OFFICE OF CLIMATE, LICENSING & RESOURCE USE

INSPECTORS REPORT ON A LICENCE APPLICATION

TO:	DIRECTORS	
FROM:	Caroline Connell	- Licensing Unit
DATE:	24 January 2012	
RE:	Application for a waste Licence from Murray Waste Recycling Ltd., Coolatore, Ferns, County Wexford, Licence Register W0258-01

Figure 2: Liquid pooling behind the percolation area.

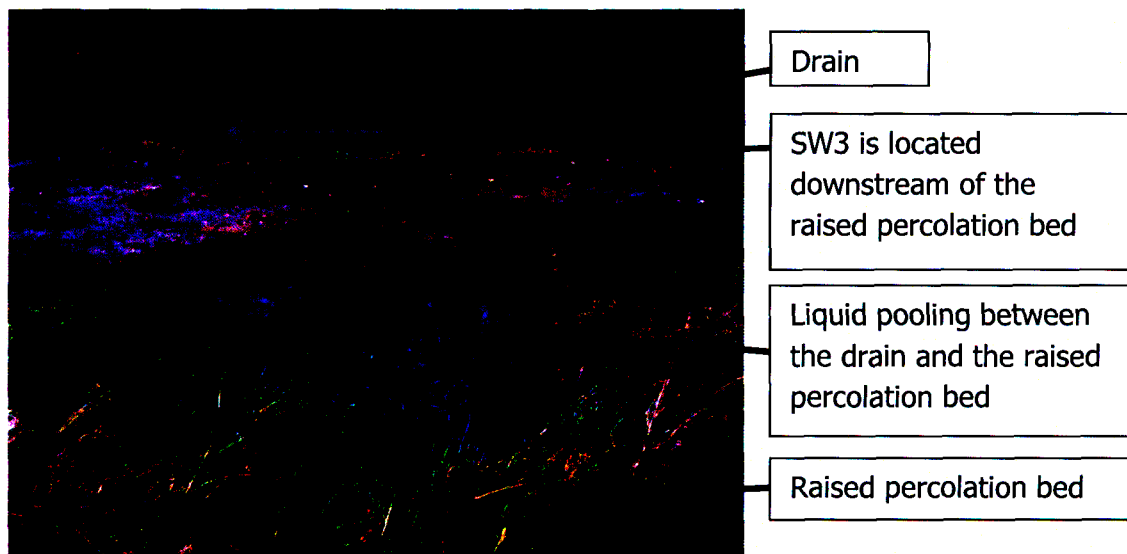
During a site visit carried out on the 16 December 2011 it was noted that there was water pooling in places at the rear of the site. The following pool of liquid was noted in the area (less than 20m) between the raised percolation bed and the drain:

This suggests that the percolation area located upstream of SW3 might not be operating effectively. However, during the site visit it was also noted that a field drain from neighbouring agricultural land flows into the drain at a location directly opposite SW3.

Condition 3.9.1 of the RD requires the licensee to demonstrate that the percolation area satisfies the criteria set out in the *Code of Practice Wastewater Treatment and Disposal Systems Serving Single Houses (p.e < 10)*, is operating correctly and is not impacting on surface water quality.

Figure 3: The location of storm water emission point SW3

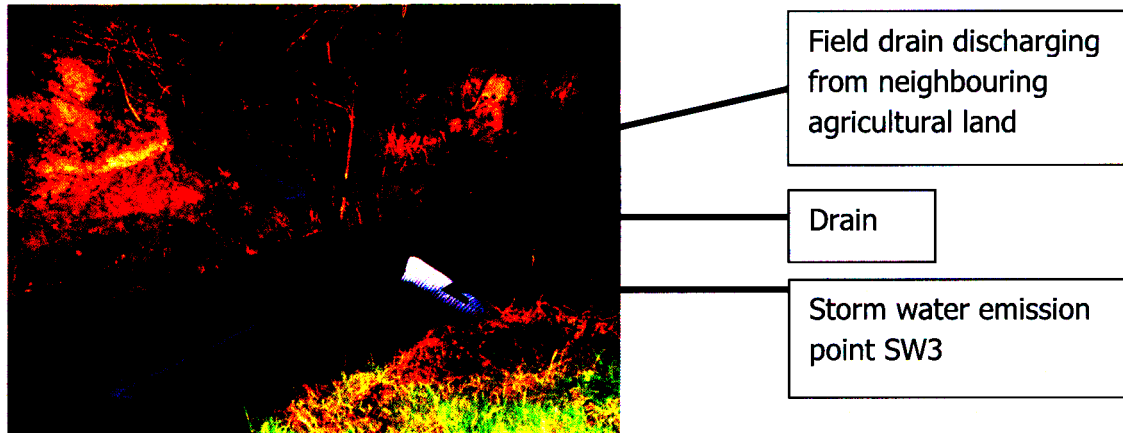
Results from monitoring on three occasions in 2008 supplied with the application suggests that when comparing SW3 to upstream water quality data that periodically there have been slightly raised levels of ammoniacal nitrogen at SW3. Levels of total coliforms and faecal coliforms detected at SW3 exceed those levels detected upstream.

The most likely sources of coliform contaminants are the percolation area or the neighbouring field drain.

Schedule C.2.3: Monitoring of Storm Water Emissions requires monitoring to be carried out for faecal and total coliforms on a quarterly basis at SW3 to confirm on an on-going basis whether faecal and total coliforms are discharged. *Schedule B.6: Storm Water Emissions* specifies emission limit values for Chemical Oxygen Demand (COD) (40 mg/l) and suspended solids (35mg/l) at SW3.

Figure 4: Wash down water management system.

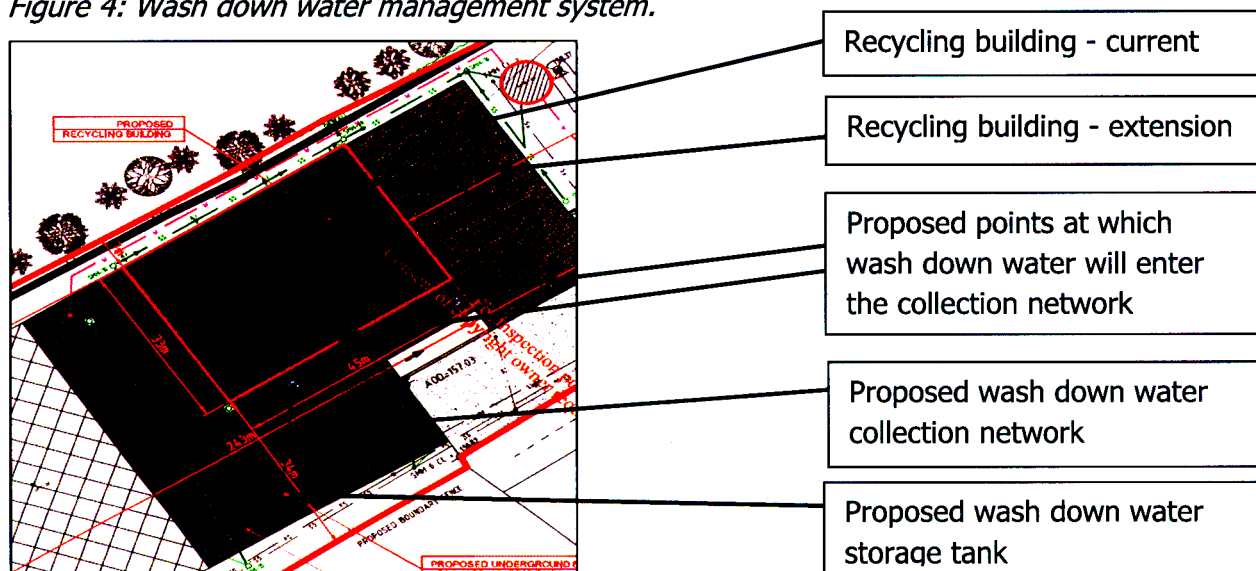
The installation of a wash-down water collection system and storage tank is due to be completed by February 2012. This storage tank will take wash down water from the recycling buildings at the points shown below in figure 4. The wash down water drainage system in the recycling building will be isolated from the storm water drainage network. Wash down water will be removed from the storage tank periodically and transported to a waste water treatment plant.

Condition 6.20 requires the applicant to wash down the floor of the recycling building on a weekly basis and any floor areas which have come into contact with putrescible waste on a daily basis. Condition 3.9.2 requires the applicant to have the wash down water collection system and storage tank installed within six months from the date of grant of the licence.
